H800 Main Board1P-0099L00-A000 (COMPEQ)  
1P-0099J00-A000 (IRIS)

TitleINDEX PAGE		
SizeCustom	Document NumberH800 MB	RevX-Build
Date:	Wednesday, October 07, 2009	Sheet1 of 50

File			
PT Changelist			
Size	Document Number	Rev	X-Build
A2	H890 MB		
Date: Wednesday, October 07, 2009 Sheet 46 of 50

File		
X-Build Changelist		
Size	Document Number	Rev
A2	H800 MB	X-Build
Date:	Monday, October 12, 2009	Sheet 50 of 50

SPI ROM

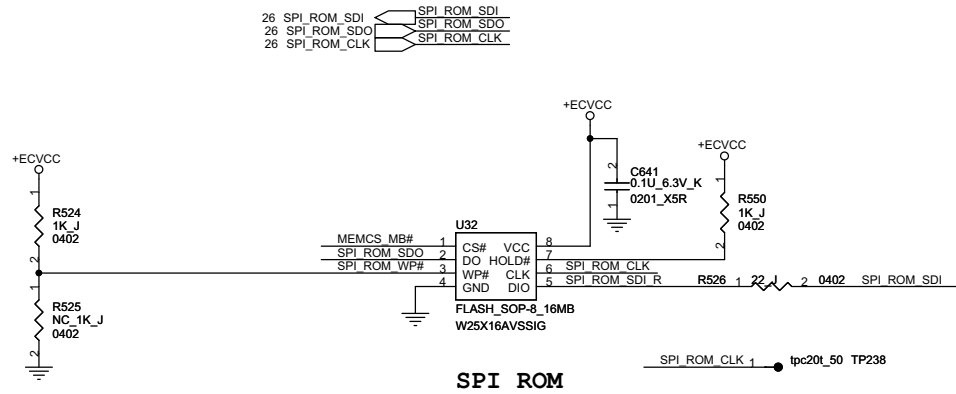
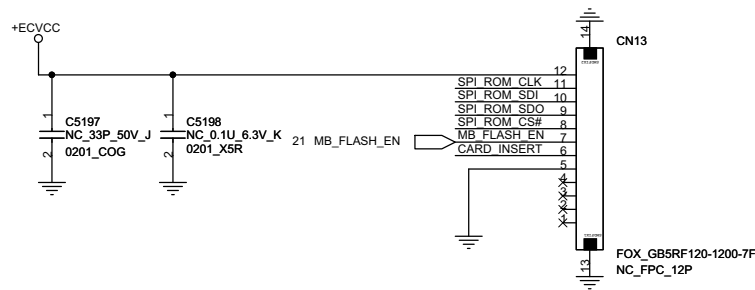
X-Build 2009.10.12  
Disabled external SPI ROM boot function and changed part value as below.  
From Mount to NC : U30,C643,R267,CN13  
From NC to Mount : R566

## FUNCTION KEY CONN

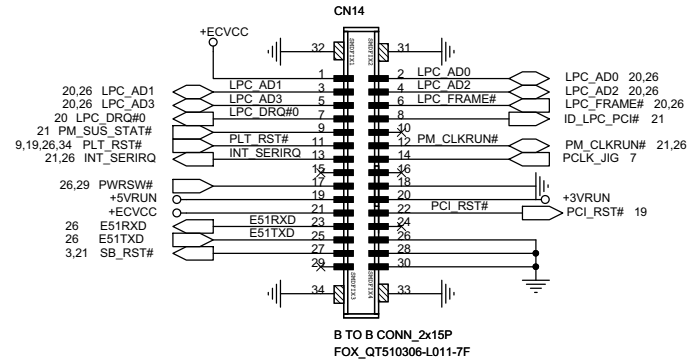
Removed on board key pad design

CN51 for test FAN power

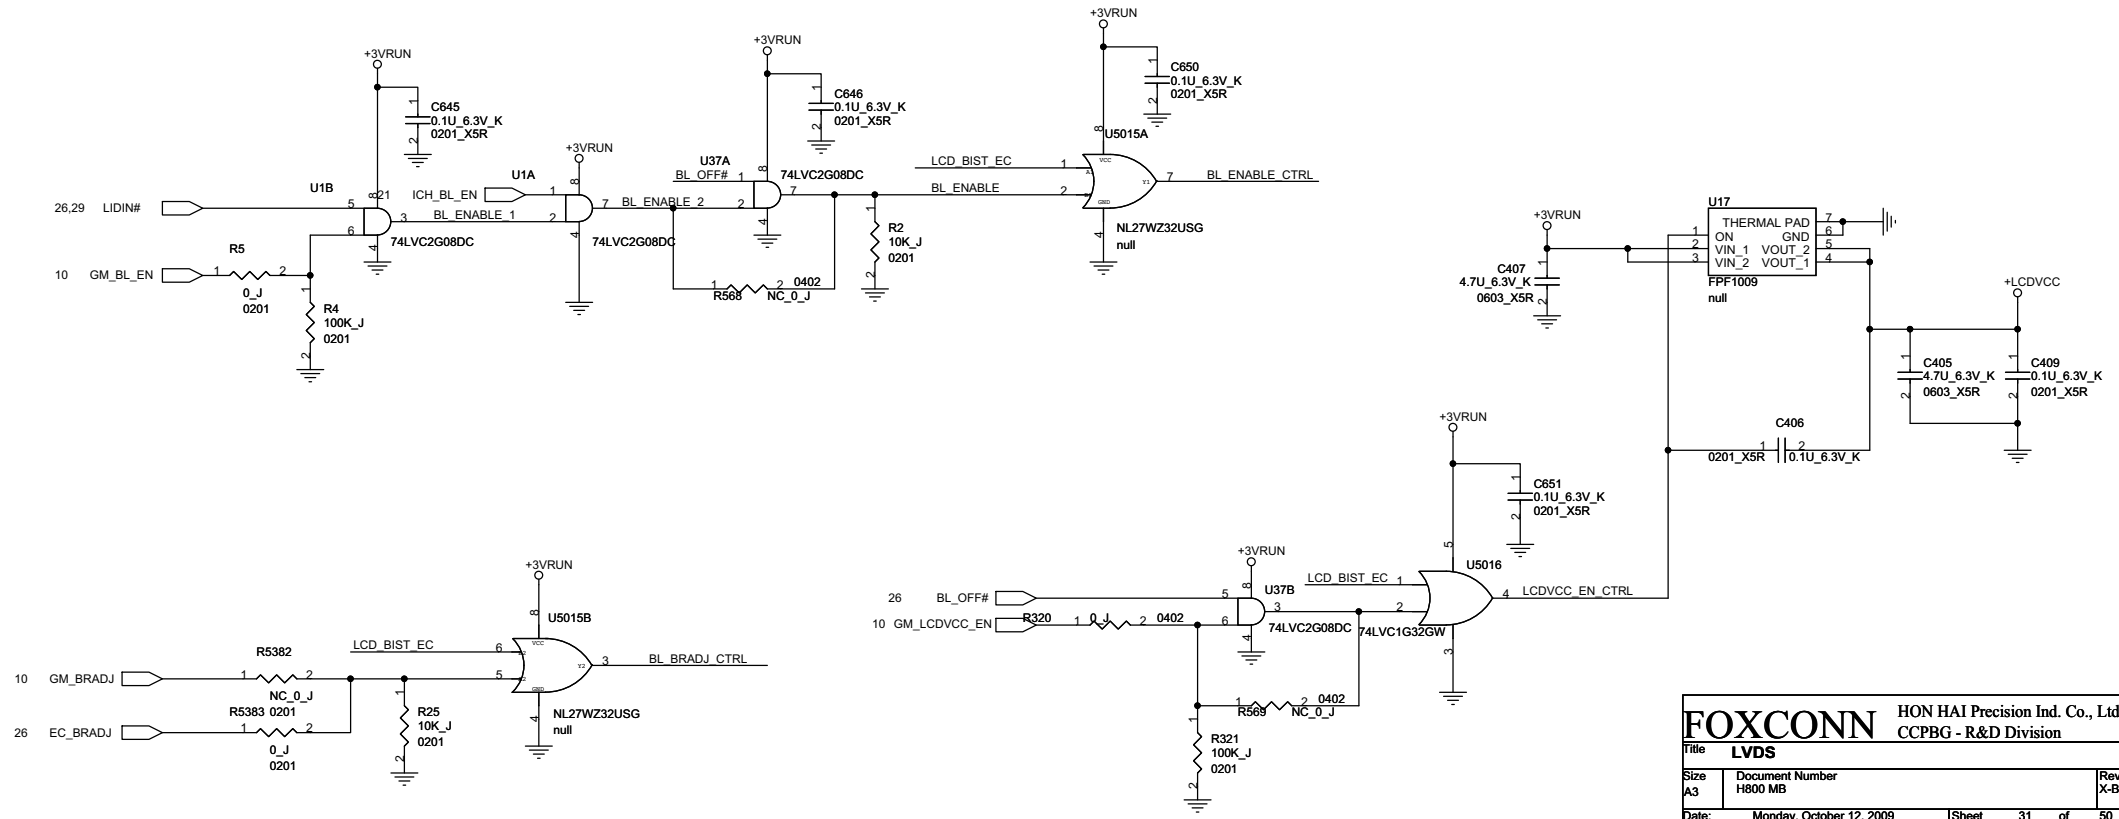
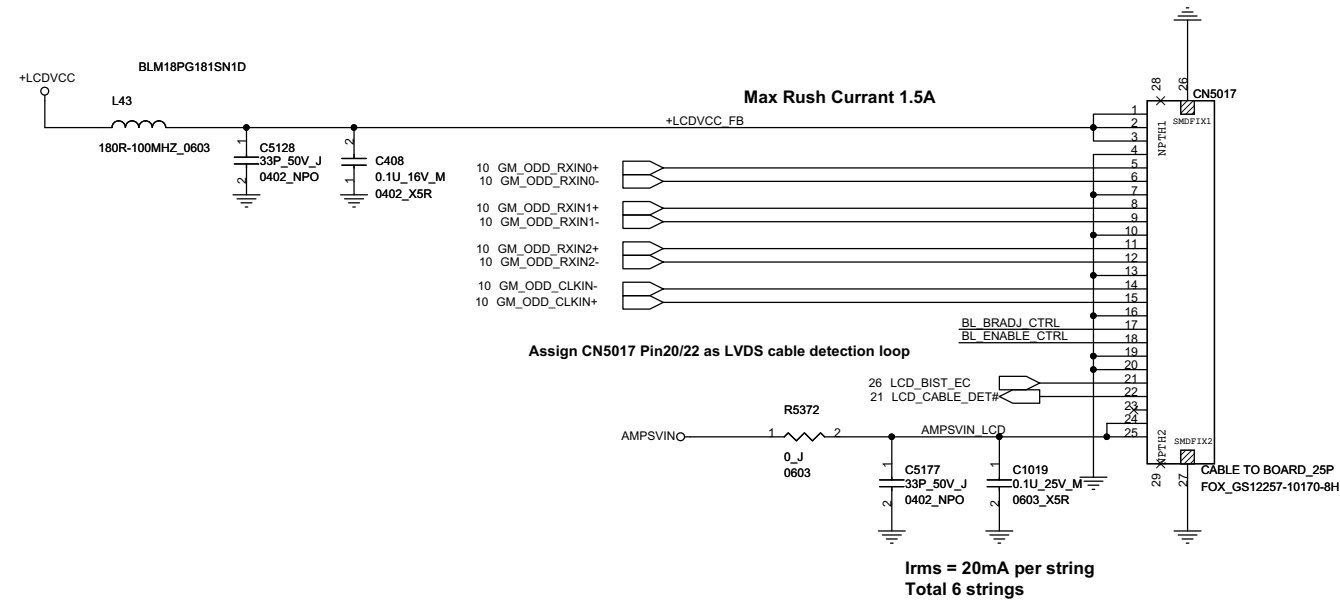
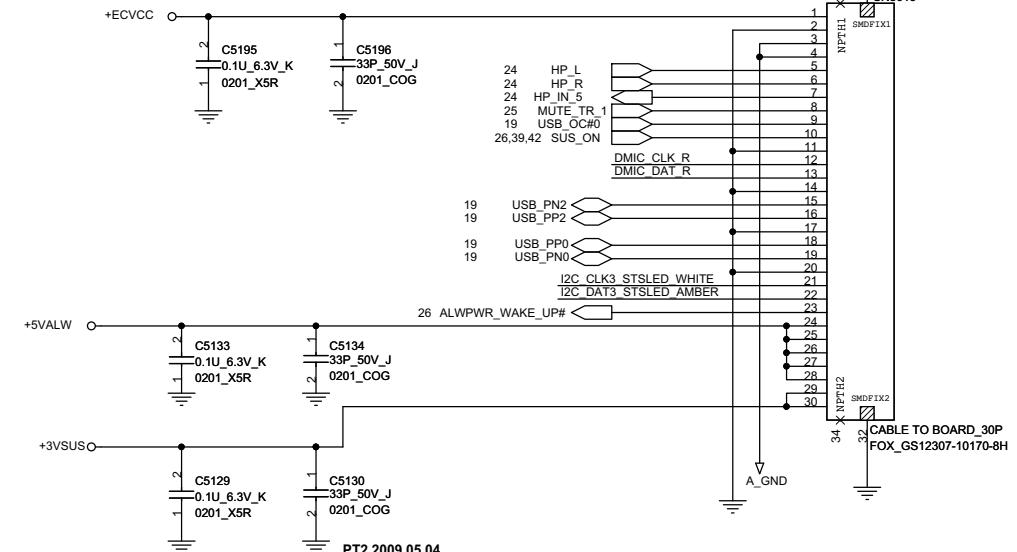
X-Build 2009.10.12  
Disabled test fan function and changed part value for CN51 from Mount to NC.
